SCOPING OPINION:

Proposed Eastern Green Link 5

Case Reference: EN0210010

13 October 2025

Figure 2

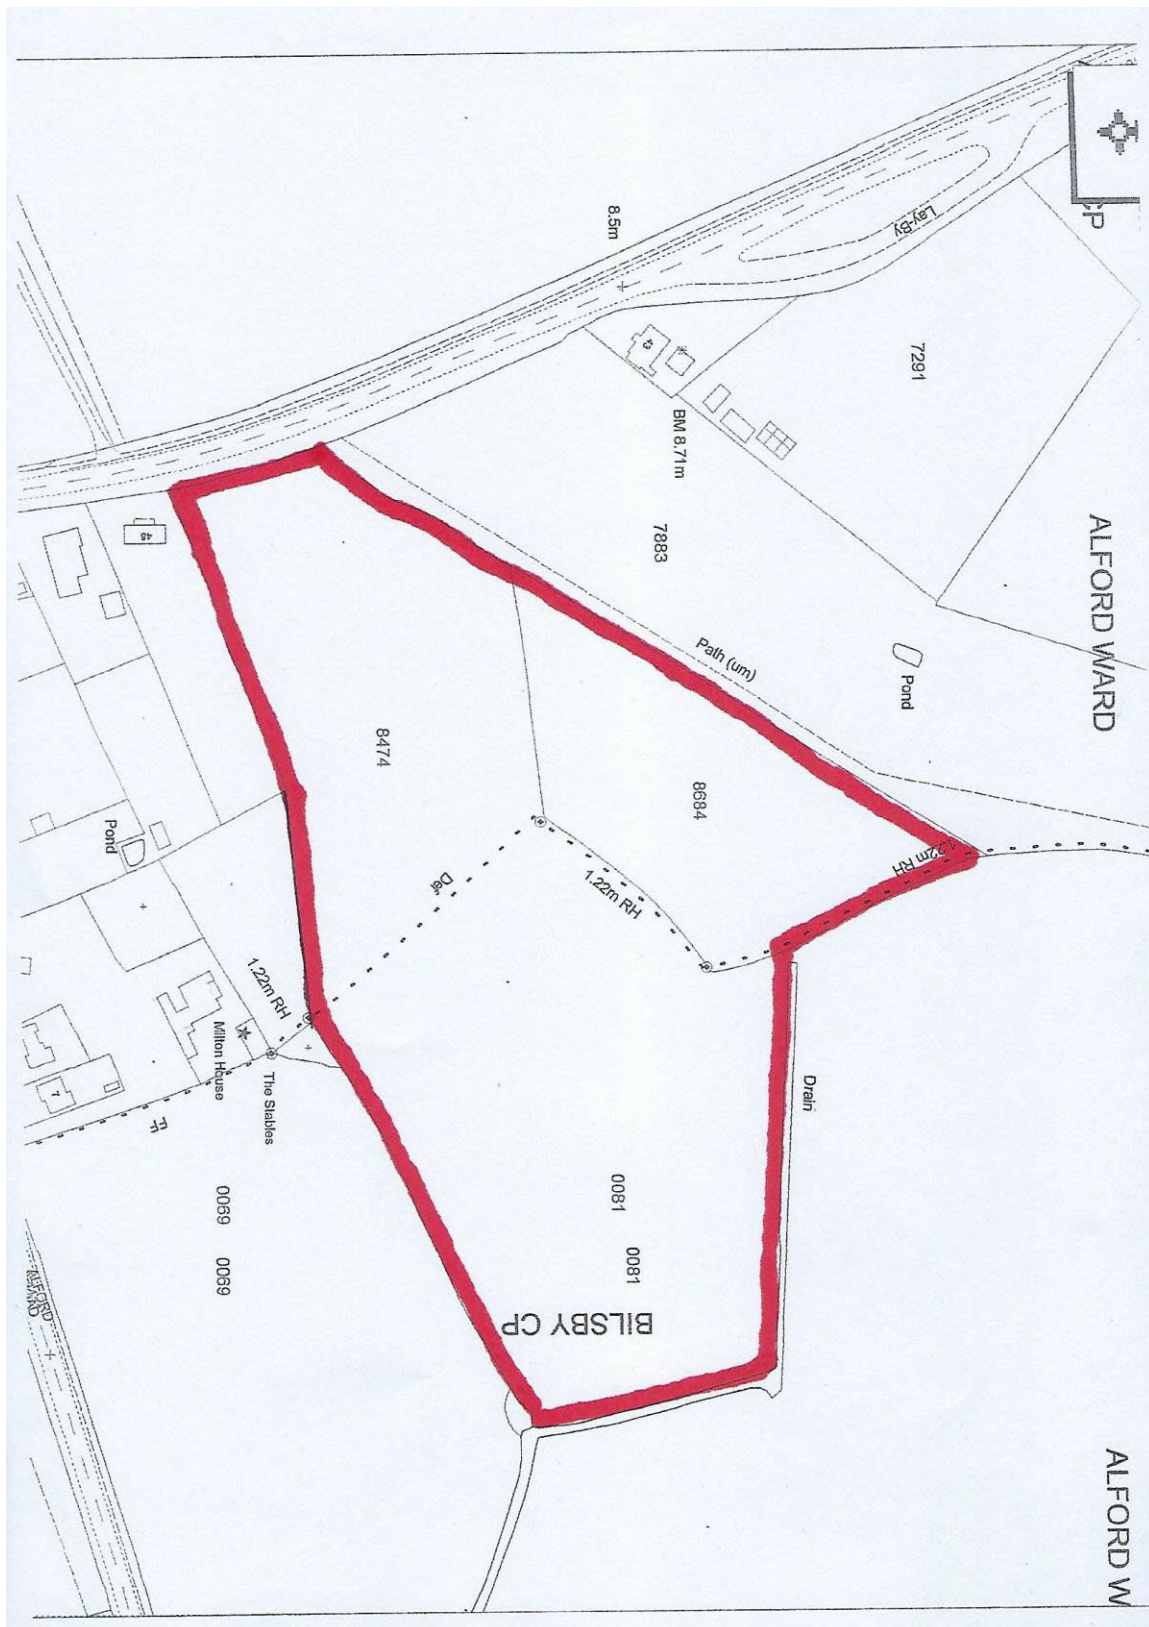
Additional Scoping Requirements – Conservation Woodland & Orchard (Fields 8684, 8474, 0081) See **Figure 2**
